ASSESSMENT REPORT - NUMBER 10

CULLEN BAY MARINA ENVIRONMENTAL ASSESSMENT REPORT

CULLEN BAY MARINA PROPOSAL

REPORT ON THE REVIEW OF THE
DRAFT ENVIRONMENTAL IMPACT STATEMENT

Figure 3: zoning plan

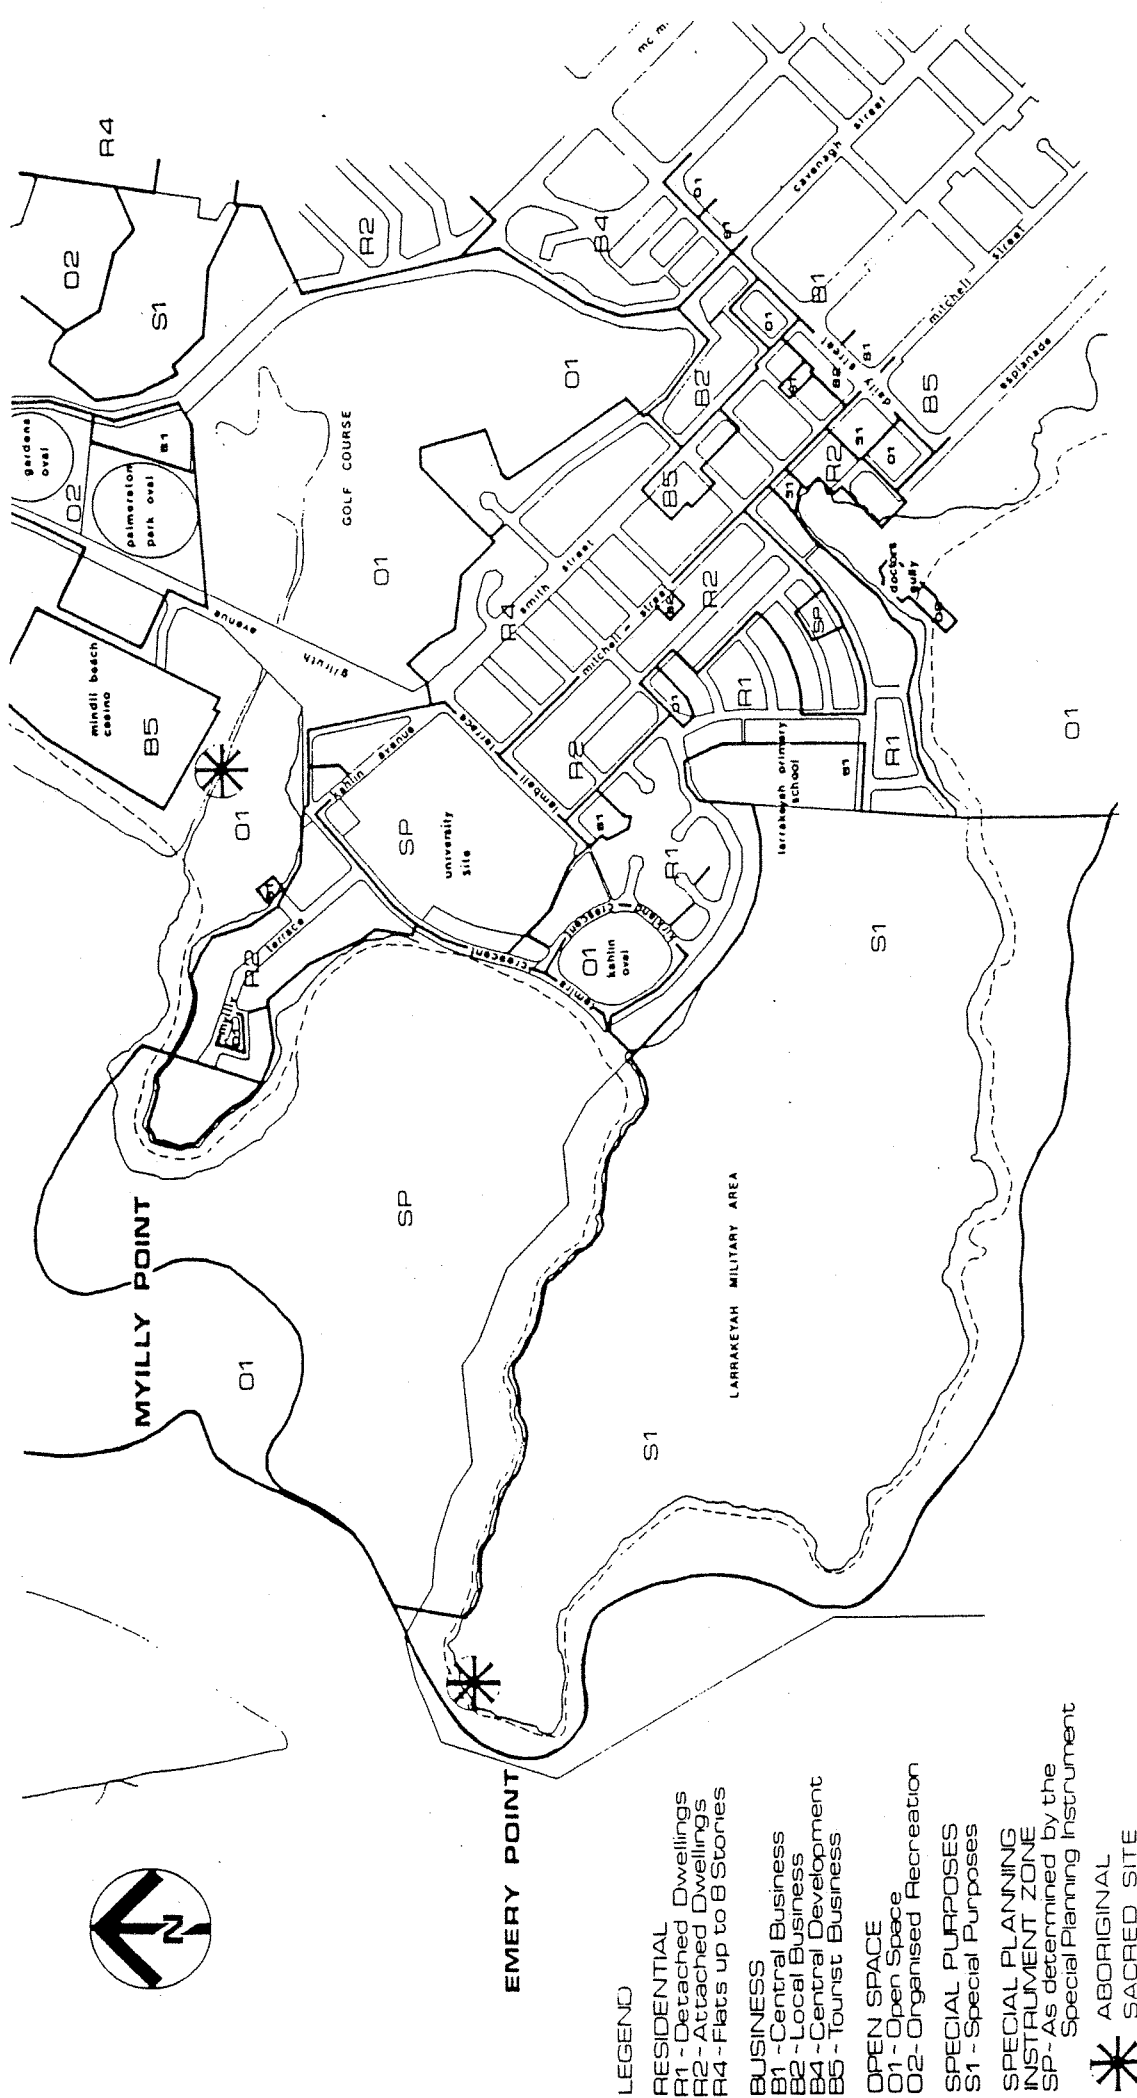
Firstly the Myilly Point Park is incorrectly noted as being within the SP zone, when it is in fact within the Ø1 zone; more importantly, the proposed Myilly Point Hotel apparently cannot proceed under the current zoning (Ø2) and cannot be considered by the Planning Authority until such time as the area is rezoned.
